CITY OF SOMERVILLE, MASSACHUSETTS
MAYOR'S OFFICE OF STRATEGIC PLANNING & COMMUNITY DEVELOPMENT
JOSEPH A. CURTATONE
MAYOR

Case #: PB 2014-01
Date: February 13, 2014
Recommendation: Conditional Approval

PLANNING STAFF REPORT

Site: 181 & 197 Washington St

Figure A. Vertical Articulation

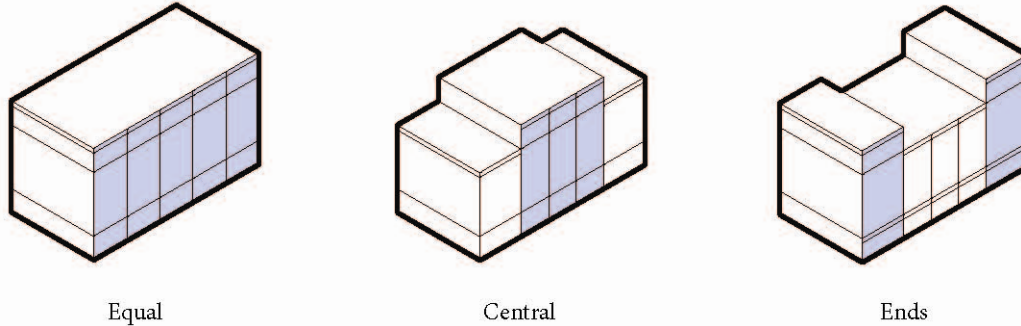
- i. The building will fill in approximately 265' of streetwall along Washington Street.
- ii. The massing and the height of the building are articulated in a manner that is compatible with the physical character of the mixed use buildings in the surrounding area. A rhythm to the building is established with a base, middle and top, with cornice lines and vertical accents to break up the building's massing. The Applicant has started an 'ends' approach (see below), similar to the guidelines of the recently approved Northpoint Zoning District. A condition of this report is that the Applicant complete this design element on the east end of the SCC building. Revised elevations shall be submitted for Planning Staff review and approval.

Flat facades have been avoided in a variety of ways. There are vertical accent bands to break up the length of the buildings including the condition above. The 4th floors use an accent material to create a ‘top’ to the building. There is a variety of materials including hardie artisan plank, metal panel, and storefront systems.
